RE: SITE PLAN – ADMINISTRATIVE DEVELOPMENT FACILITATION TEAM
PR-2024-010691, SP-2025-00031
7520 RAINBOW BLVD NW; LT 11-A BLK 2 PLAT OF LTS 10-A, 11-A, 19-A THRU 22-A BLK
2UNIT 14 VOLCANO CLIFFS SUBD CONT 2.0312 AC

Please see responses to DFT comments for **PR-2024-010691**, **SP-2025-00031**. Also included are the updated construction drawings to address the comments.

1 EXTERIOR ELEVATION & PROFILE PLAN NORTH SCALE: 1" = 10'-0"

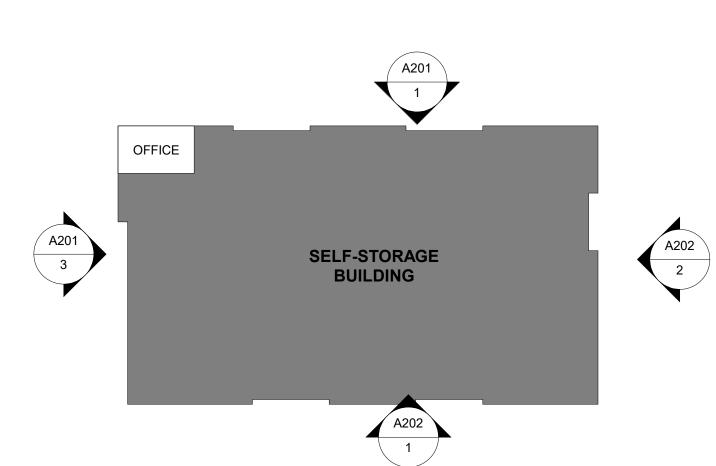
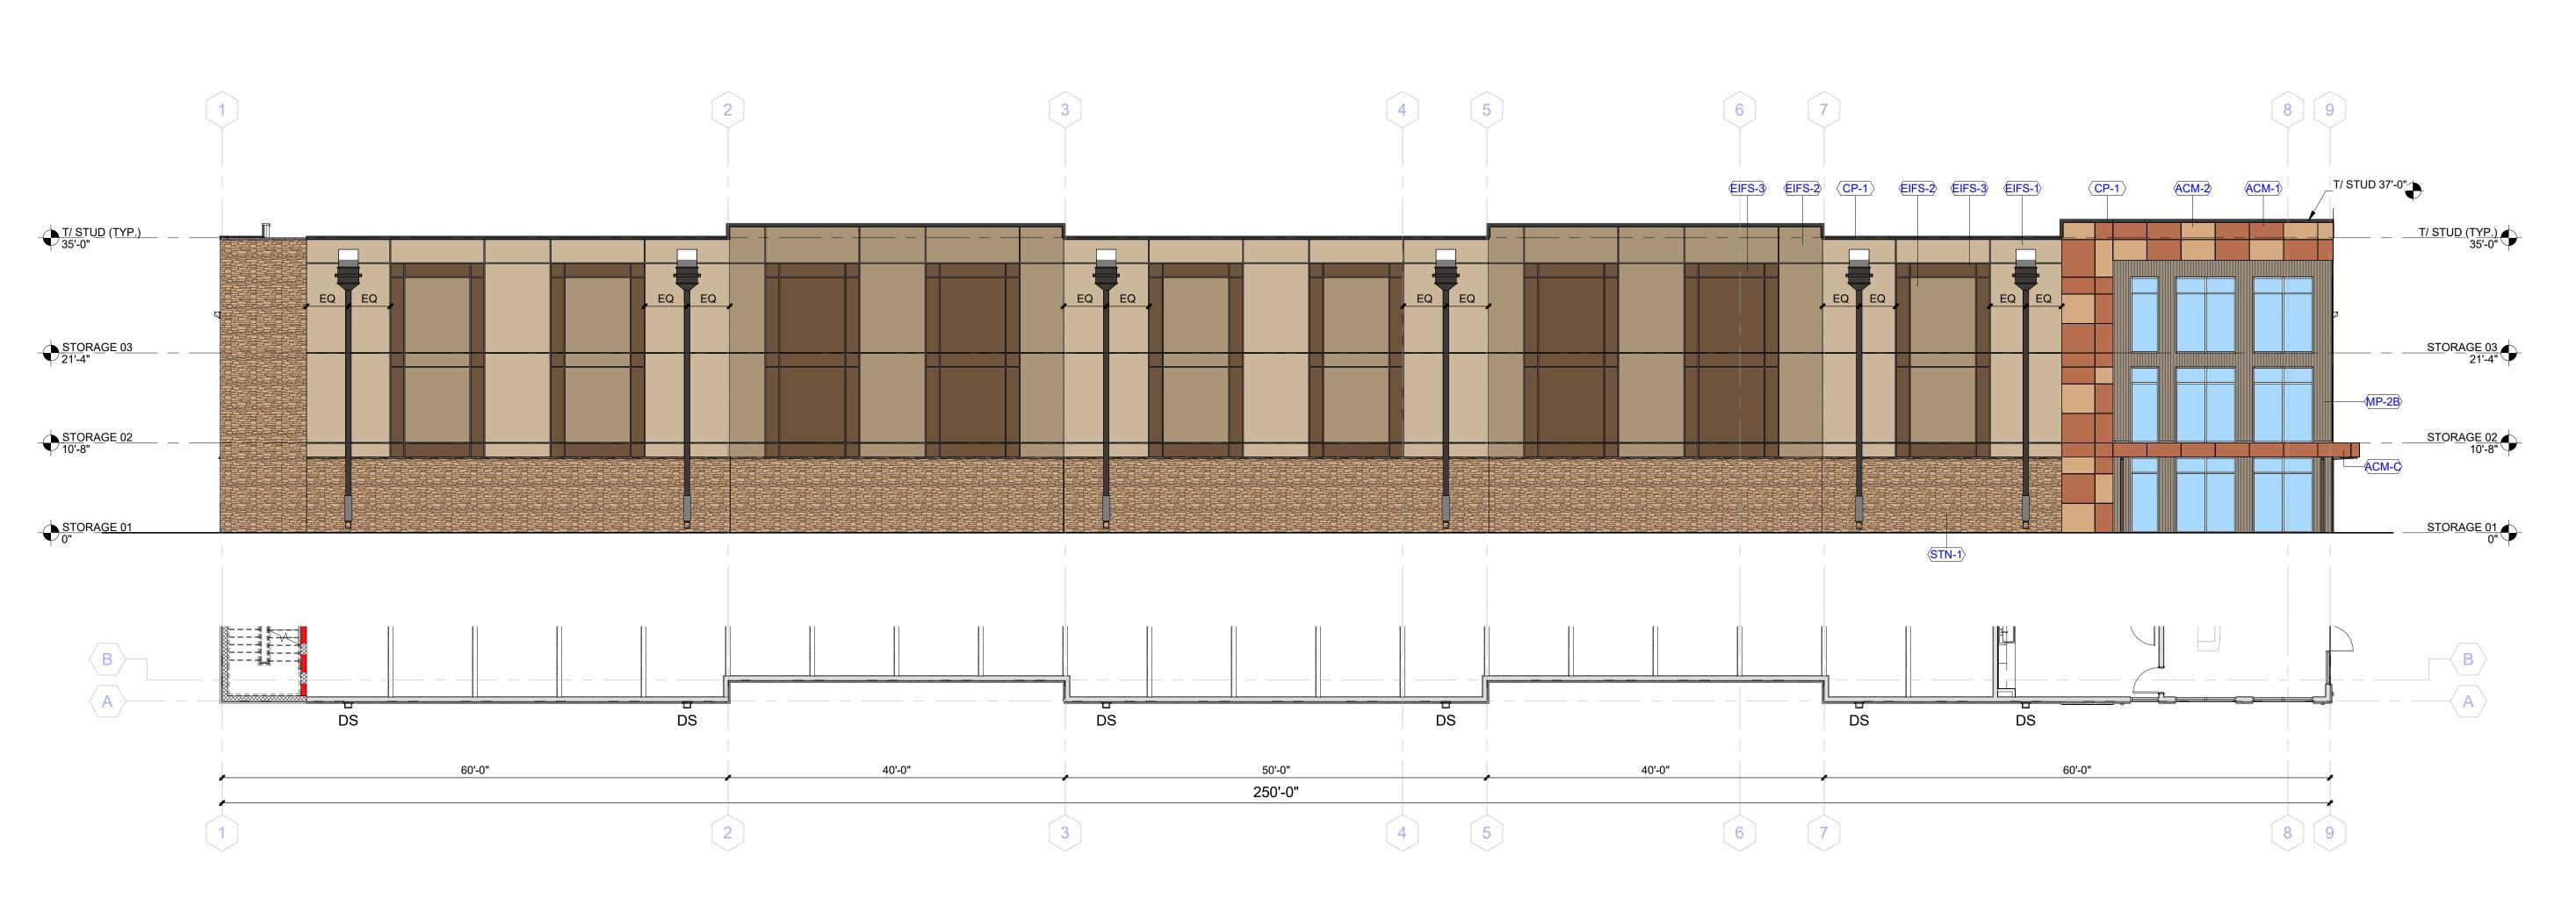
- 1. Lighting: Must add location of light fixtures on elevations and notes indicating the compliance in the Elevation Plans, or provide separate Lighting details sheet for those purposes.
 - a. Provide sheet giving lighting types and details, showing how lighting complies with Sections 4-3-D-29 and 5-8 of the IDO (as in response to prior Planning comments).
 - b. Must show how meeting requirements for Light Trespass, as per IDO 5-8(F)(4).

RESPONSE: Building Exterior Elevation sheets have been updated to identify the lighting plan.

1 EXTERIOR ELEVATION & PROFILE PLAN - SOUTH A202 SCALE: 1" = 10'-0"

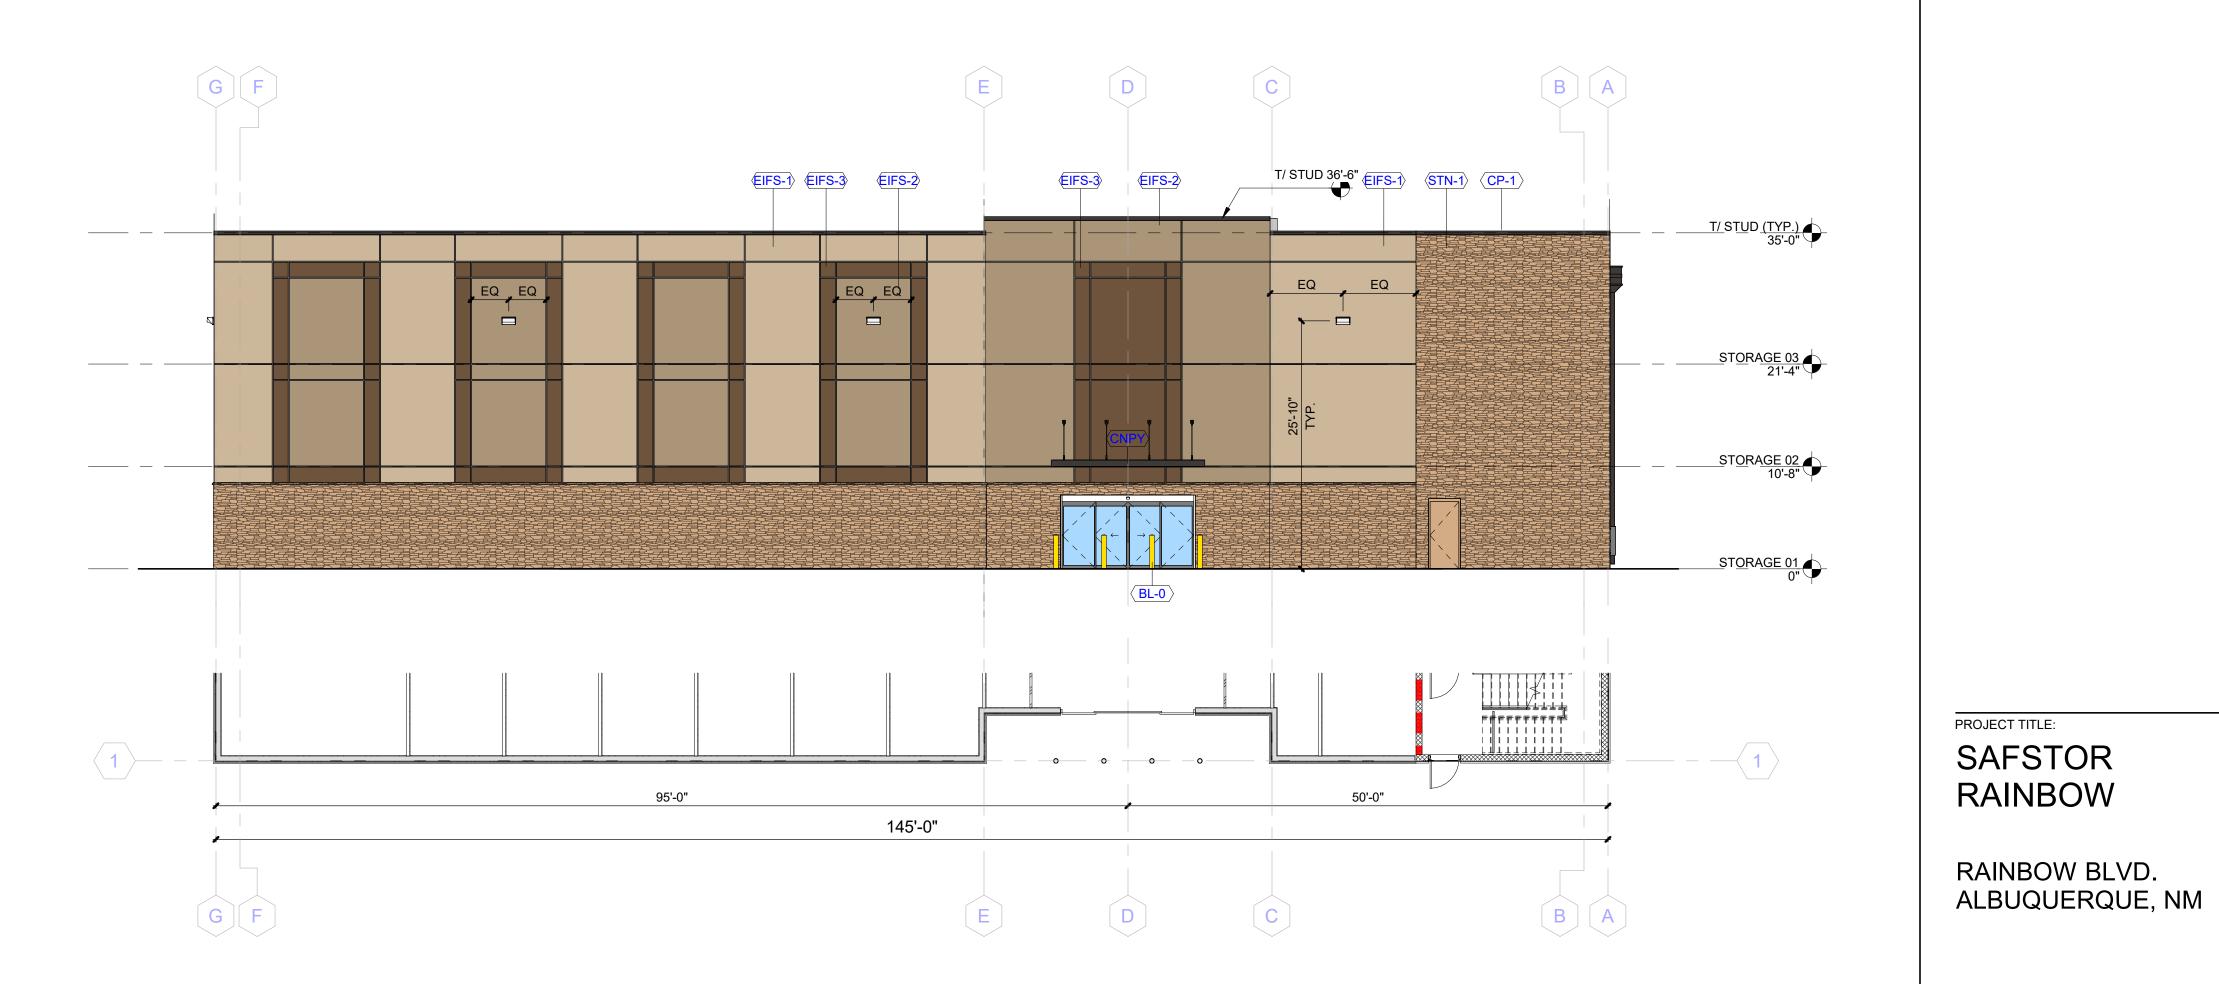
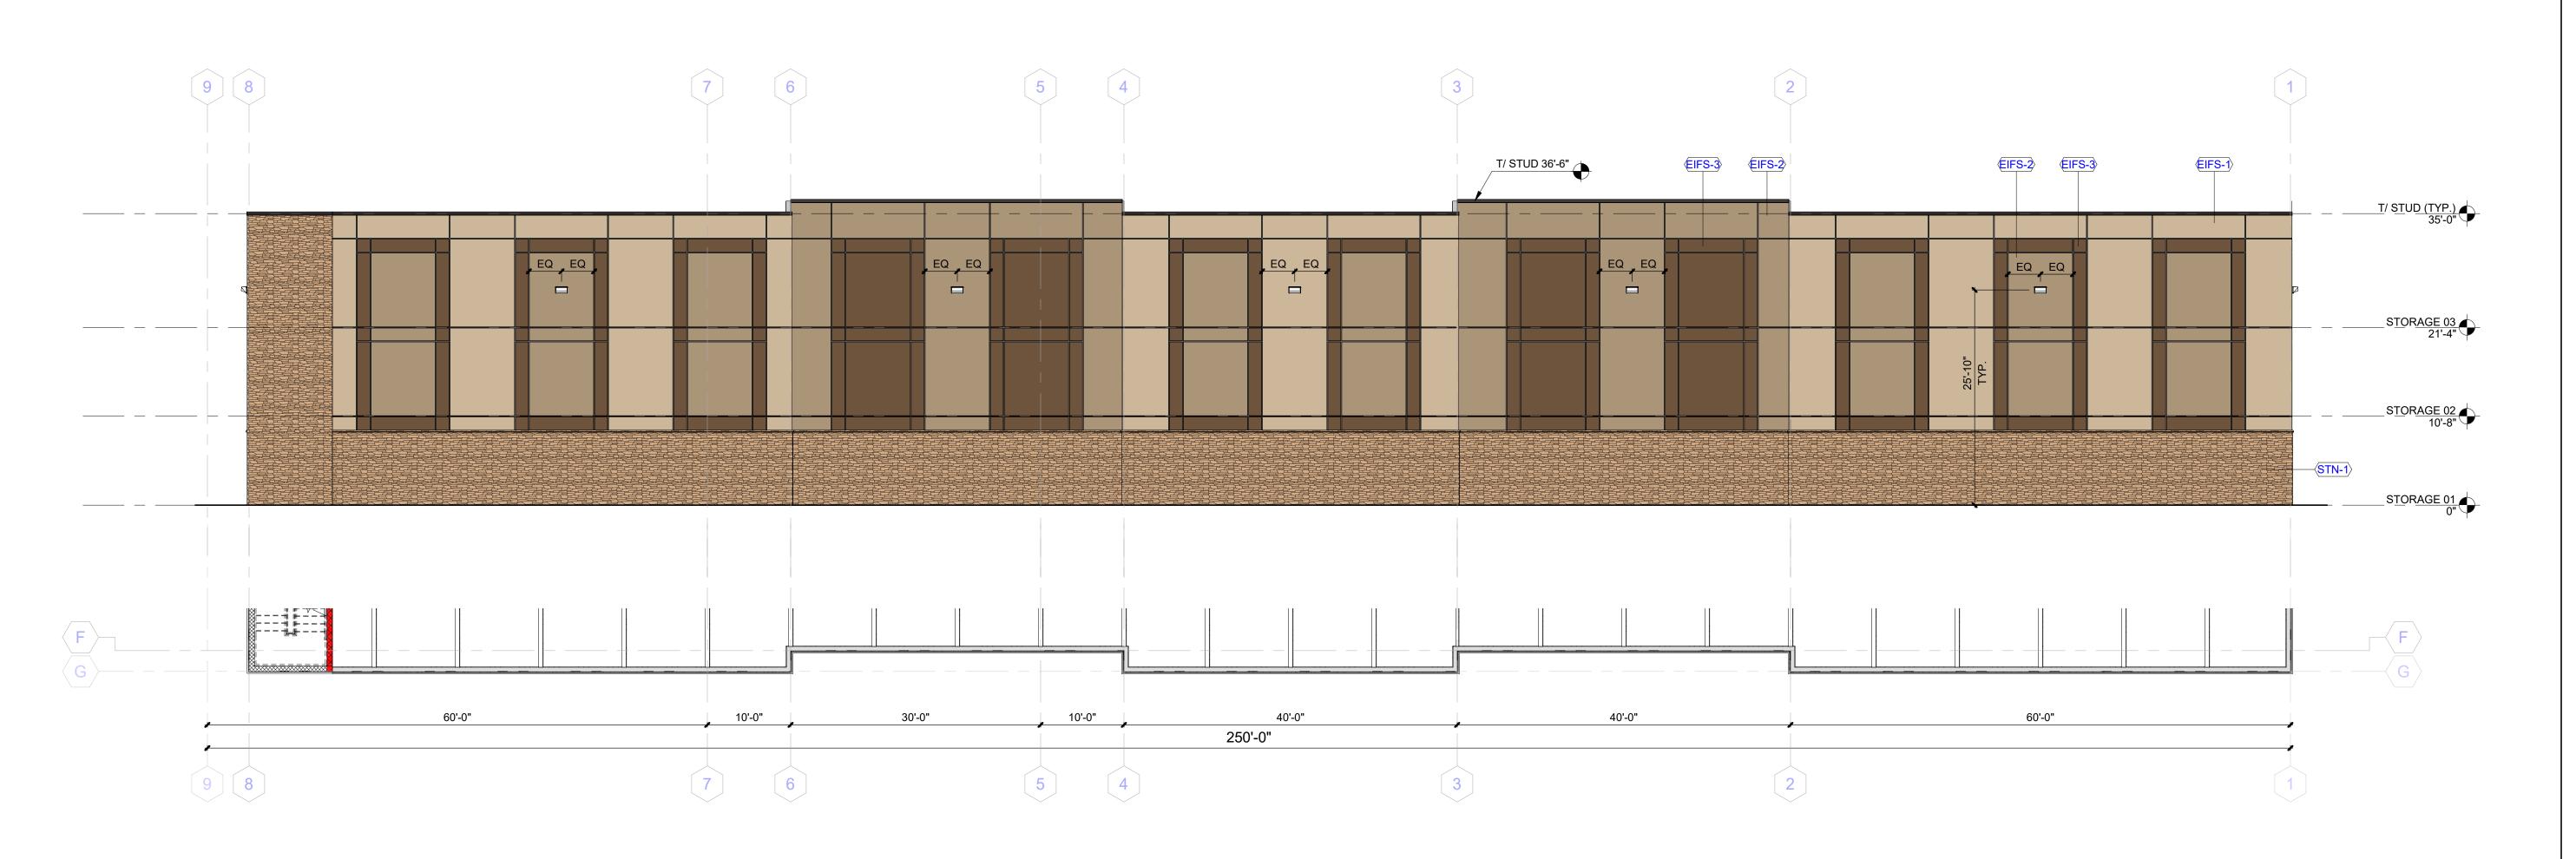
- RESPONSE: Site Plan and Landscaping Plans have been updated to identify the sidewalk and buffer dimensions along the frontage.
- 3. Provide a lighting plan with dimensions that meets IDO section 4-3-d-29, and section 5-8.

- RESPONSE: Building Exterior Elevation sheets have been updated to identify the proposed lighting.
- 4. Confirm whether the trees shown in the landscaping plan were recommended by the City Forester.
